PARTS & SERVICE NEWS

REF NO.	AT02152A
DATE	Nov. 1, 2002

SUBJECT: REPAIR PROCEDURE OF OIL LEAK FROM TRANSMISSION REAR COUPLING (SLIDING TYPE)

APPLICATION: WA200-3 Wheel Loaders, S/ N up to 64388, 64394, 64399
 WA250-3 Wheel Loaders, S/N up to 60049
 (Transmission S/N 180146, 18015 thru 180163, 180185 thru 180187, 180192 thru 180220)

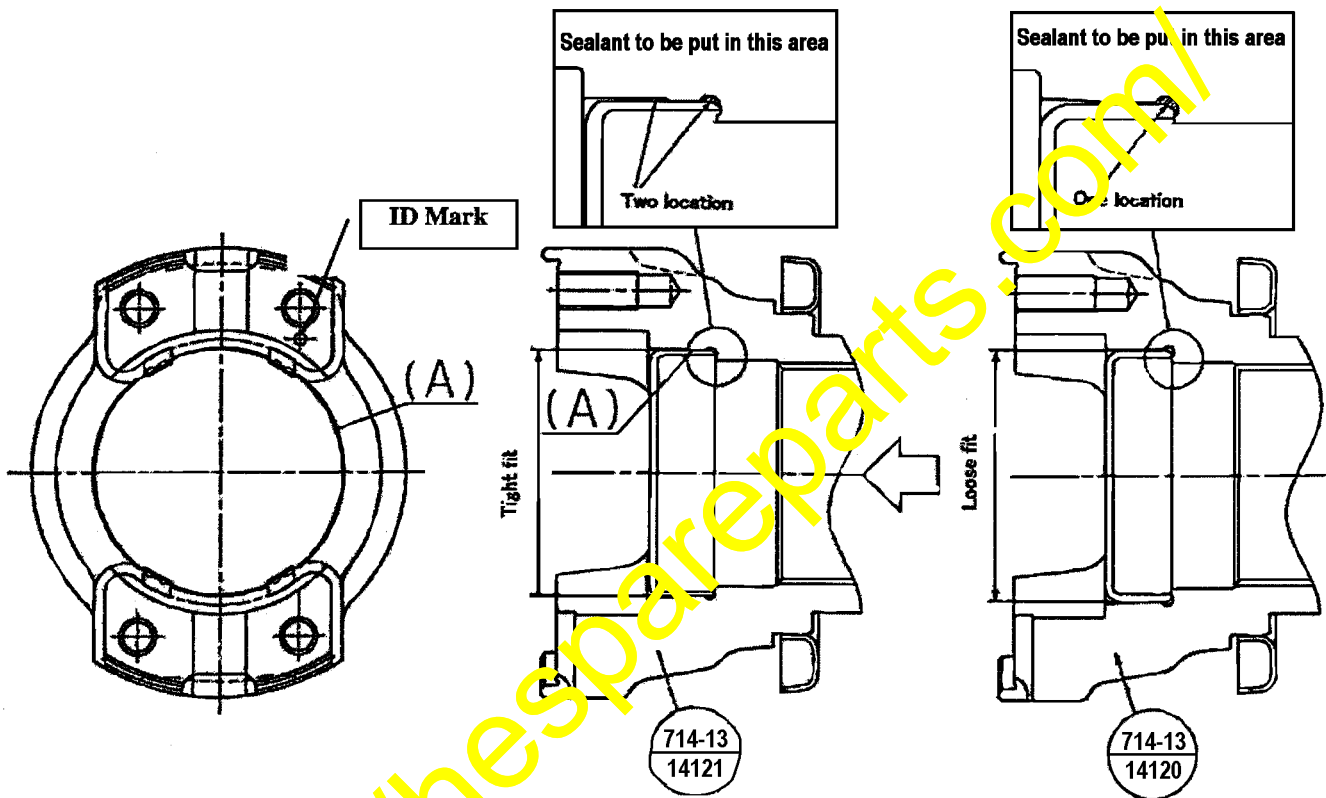
There is a possibility of oil leak from between coupling and cover indicated (A) in the drawing below. It has been improved changing the clearance tolerance from loose to tight fit.

The location on which sealant putting is increased one to two as indicated in the drawing below.

In order to clarify the improved coupling the ID mark is punched as shown in the drawing below.

Parts No.	Parts Name	Treatment	Qty.	Remarks
714-13-14121 (714-13-14120)	Coupling	Replace	1

Replace the coupling according to the instructions in the Shop Manual.
